C-A Unreviewed Safety Issue (USI) Form

Title of USI: *Changes to ODH Protection*

Title and Date of Relevant SAD: *SAD for the TVDG Facility, 11/28/95*

Calculation of Oxygen Deficiency Hazards for TVDG

FIGURE 1: BUILDING 901A FLOOR PLAN

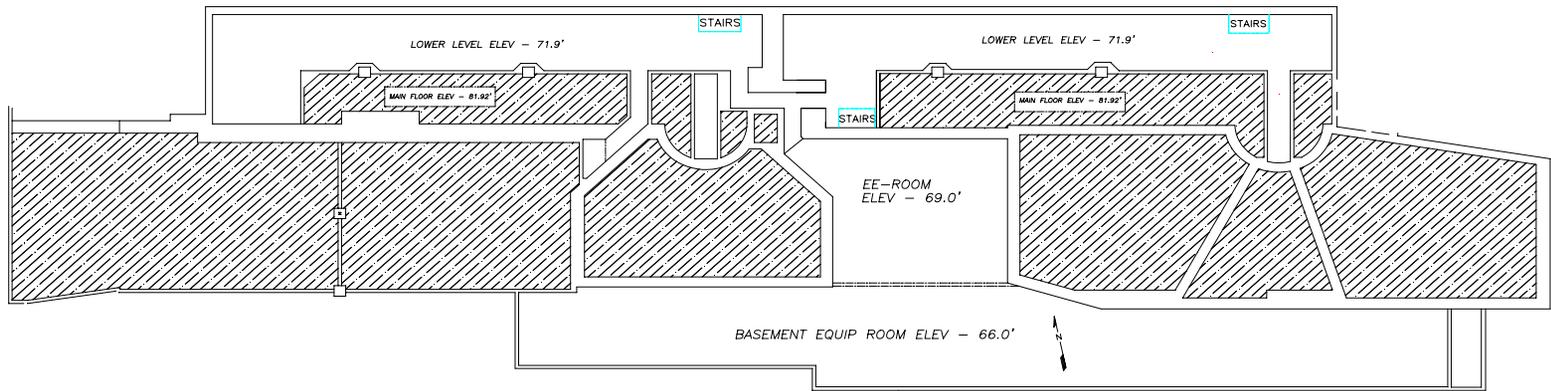
L. Snyderstrup presented his preliminary "Calculation of Oxygen Deficiency Hazards for TVDG", dated 10/8/01 to the Committee. He reviewed the configuration of the TVDG building by using a plan view of both floor levels. The primary rooms that have potential sources of the MP insulating gas (45% SF₆, 45% N₂ and 10% CO₂) are the accelerator room (AR), mechanical equipment (ME) room and the gas storage building located on the hill above the TVDG building, south of building 704. TVDG rooms that can have insulating gas leak into them from these primary rooms are: the electrical equipment (EE) room under the control room via a cableway from the AR; the basement, via the EE room and target room trenches; and the TTB via the AR. There are four target rooms that have no credible paths to accumulate insulating gas from the AR.

Questions focusing on the audible alarms, determined the need to provide an additional ODH alarm in the EE room, basemen area.

3. The calculation needs to be revised to include the additional failure mode of the emergency purge system air operated dampers.
4. An additional audible alarm needs to be placed at a location that can be heard in the EE room and the basement to warn personnel when an ODH hazard exists.

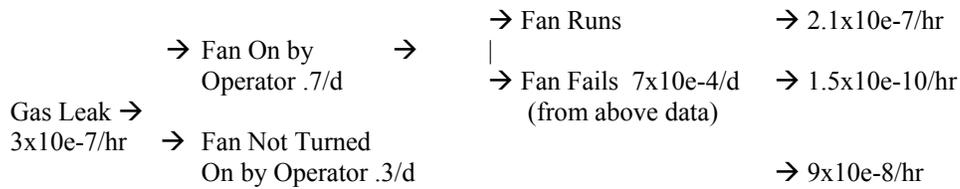
Cirnigliaro asked if failure of the exhaust purge duct and purge fan dampers was considered in the calculation that determined the exhaust purge system failure rate. Snyderstrup stated that it wasn't. The dampers are air operated. Glenn asked that the calculation be revised to include this additional failure mode.
